SHELTON APARTMENTS

2359 FRANKLIN AVENUE EAST

Design Review Board Recommendation
October 22, 2014 • 8pm
DPD # 3016711

Design Review Recommendation Meeting
Meeting Date: October 22, 2014

APRIL 09, 2014 EDG IMAGE: West Elevation

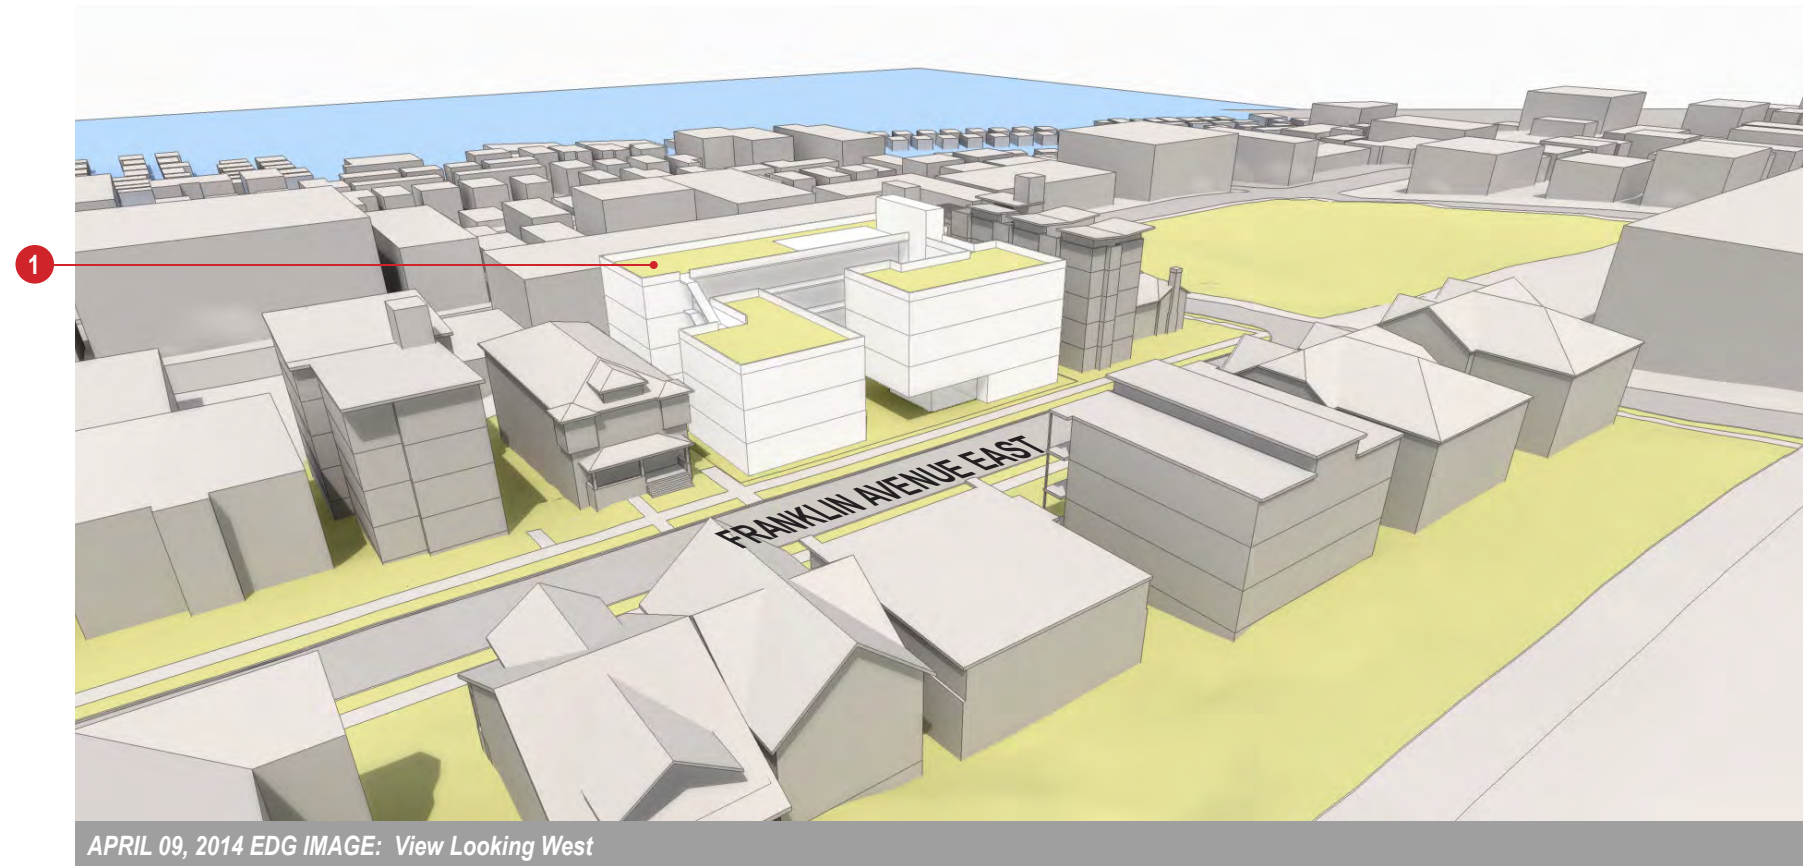
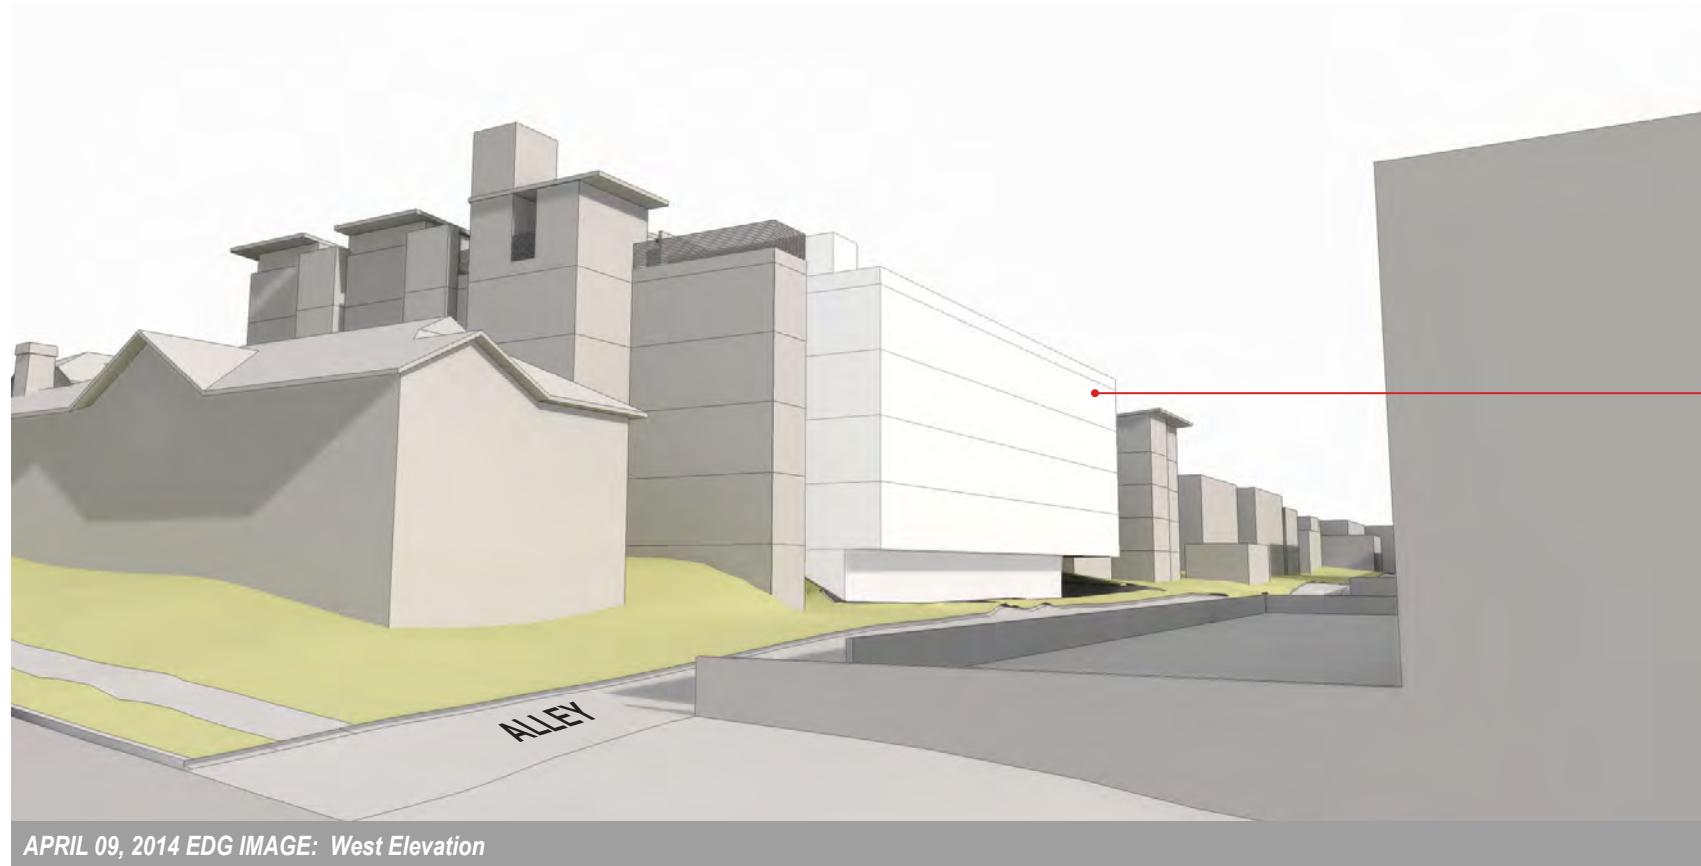
EDG #1: *Massing and Height, Bulk & Scale: The Board agreed the applicant should proceed with the preferred Alternative 3. They noted the proposed massing relates well to the existing development to the north and south of the site, and supported the break in the massing along Franklin Ave E as it created a pedestrian friendly front to the street. (CS2.D, PL1.B)*

- a. *Maintain the lower height of the southeast section or wing of the structure adjacent to the existing development to the south. (CS2.D.1 & 5)*
- b. *Consider providing a gap in the massing to provide a limited (peek-a-boo) view to the west from the east. (DC2.A.2)*
- c. *Maintain the asymmetry of the massing and the ground floor concept along Franklin Ave E. (DC1.A.4, DC2.A.1)*
- d. *Provide articulation and modulation to break up the west elevation. The Board stated they would consider granting a departure from the required rear setbacks to allow for the modulation but this modulation should not provide additional enclosed floor area. (DC2.B.1, DC2.C.1)*
- e. *Carefully consider the location and height of the stair penthouse. (CS2.D.1)*
- f. *Consider how the project will appear from Eastlake Ave E. (DC2.B.1)*

The proposed building massing has been revised based on feedback from the Board at the EDG meeting and itemized above. We have maintained the lower height (3-stories) of the southern portion, the asymmetry of the massing, and further extended the 3-story wing to the west which breaks up the scale of the building from Eastlake Ave and provides a gap in the massing for west views through the site, as suggested in b. above. This erosion of the mass is offset by extending the building to the west into the rear setback (a design departure is requested per d. above - please see page 33 for more information). The west portion of the building is further eroded with exterior decks that provide articulation and modulation to this visible façade and are larger at the fourth level, to further modulate the west elevation. The two revisions have not resulted in adding enclosed floor area, which is governed by the FAR limit of 2.0 and is not departable. Lastly, the elevator penthouse has been located to the north, adjacent to the taller neighboring building.

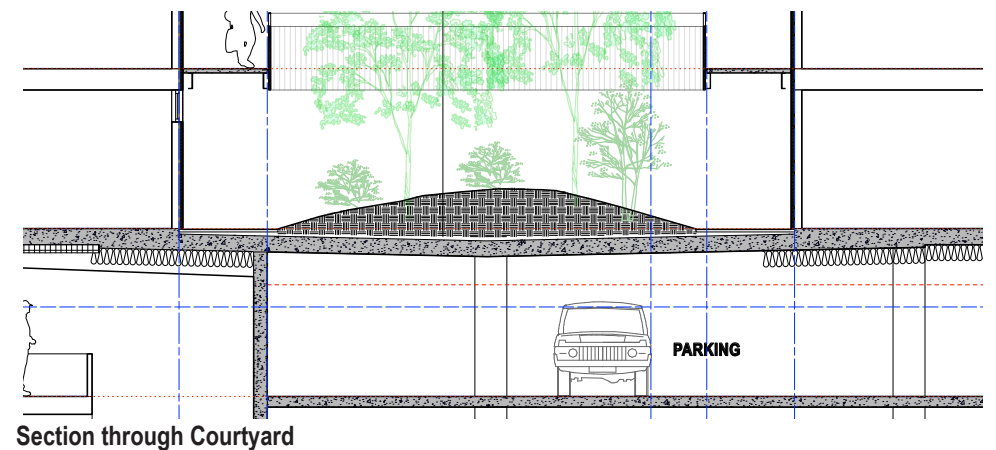
EDG #2: *Courtyard and Landscaping: The Board expressed support for the courtyard and noted it was the front door of the project. (PL1.B.3, PL3.A.1, DC2.D.1)*

- Design the courtyard and garage below to structurally support and provide enough soil for trees to grow. The execution of the courtyard should allow all the landscaping to flourish. (DC4.D.2 & 3)*
- It was noted the courtyard may not work as a gathering place. (DC3.B.1)*
- Consider "further erosion" of the courtyard. (DC2.A.1)*
- Keep the design of the courtyard with the landscaping spilling out to the street as this relates to the neighborhood. (CS2.B.3, DC2.C.3)*

EDG #3: *Entries: The Board discussed whether the ground unit entries should be from the street or off the courtyard, but decided that entries off of Franklin Ave E was preferred. (PL3.A.3)*

- Consider a deeper setback along Franklin to provide more area for individual entries. (PL3.A.3)*
- Treat the courtyard entry as the main entry to the site. (PL3.A.1)*
- The Board questioned if there will be an entry gate for security. The applicant responded that security will be provided at the end of the entry ramp near the front door to the lobby. (PL3.A.2)*

The courtyard has been structurally designed to support adequate soil for landscaping and large trees, as shown on the Landscape Plan to the left and the section detail below. Also, the courtyard has been developed to offer a small gathering / staging space adjacent to the integrated bike storage area at the courtyard level (please see A102) and the plantings are designed to provide continuity between private property and the newly planted adjacent public spaces along Franklin Ave which will have new street trees and plantings.

The design team studied individual private entries along Franklin Ave to the ground level units and concluded that it was strongly preferred to develop the courtyard as the main entry to the site, and allow the ground level units to also be accessed from the courtyard similar to the upper floor units. Individual entries off the street created security concerns for those residents, and diminished the "main entry" character of the covered entry, lobby, and courtyard sequence as supported in EDG #2. The proposed design offers a single front door to the project, and we have introduced ground level patios to select ground level units to give these residents access to the exterior and engagement at street level while simultaneously protecting the security of the residents.

Proposed Exterior Materials

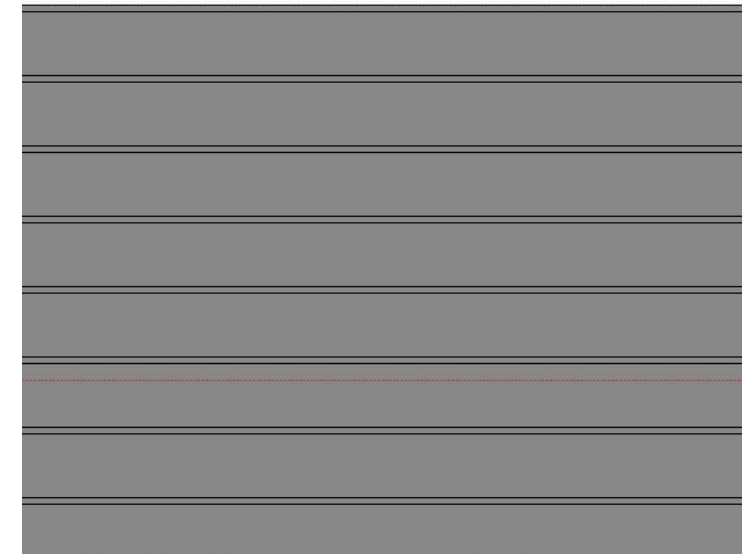
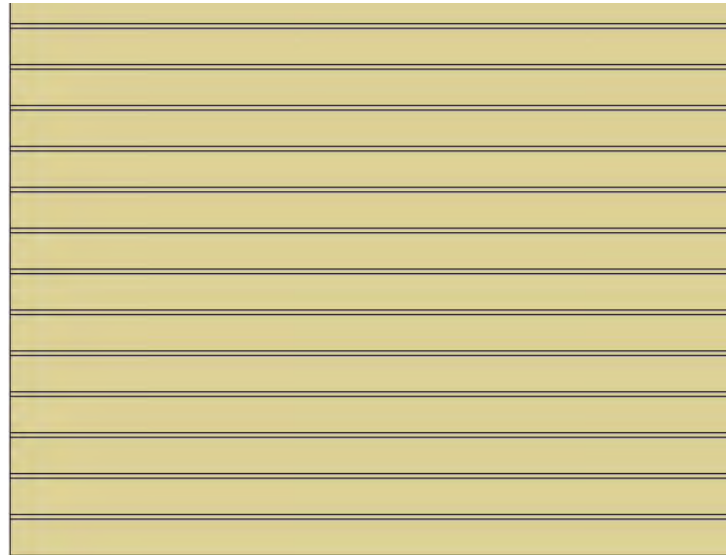
EDG #4: Materials and Context: The Board directed the applicant to study the existing character of the street and use this as a cue to inform the design. The Board noted that the neighborhood has an eclectic use of materials and advised the applicant to wisely choose which of these materials to use. The applicant was asked what materials they were considering. The applicant responded that their goal was a unified building and that they were considering brick and cedar siding in a similar color to the brick. (Cs3.A.4, DC4.A.1)

- a. Provide a unified materials palette for all the exterior facades. (DC2.A.1, DC4.A)
- b. Consider brick as a material. (DC4.A)
- c. Provide ample fenestration. (PL2.B.1)
- d. Explore the use of materials to enhance the context of the neighborhood. (CS3.A.4)
- e. Consider a green roof to soften the loss of views. (CS2.D.5)
- f. Preserve the existing path and staircase to the alley located on the property to the south. (CS2.D.5)

The proposed building integrates generously sized windows for daylight, with large operable sash for natural ventilation, brick exterior cladding, and rainscreen siding in two horizontal sizes and colors, 4" and 6". The primary exterior materials (brick (#1) and 6" horizontal rainscreen (#2)) will be of similar tone and scale, thereby unifying the composition while providing subtle texture and material differences. The proposed building strives to continue the typology of permanent, high-quality, 3-4 story brick apartment buildings found throughout the Eastlake neighborhood. In addition, the project integrates vegetated, green roofs, that will be both an amenity to residents, assist with the management of storm water, and offer an aesthetically pleasing roofscape view from uphill neighbors to the east.
